Bulletin type: **FIELD FIX CONDITIONAL**

Subject: SEGE passenger seat recline
lever improvement

Bulletin Number: **TS45-FC-2403**

Vehicle Model: **TS45**

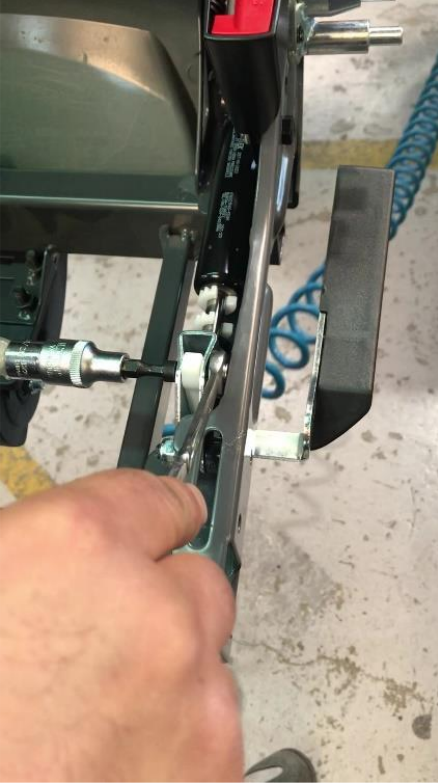
5- Remove the metal part by hand.
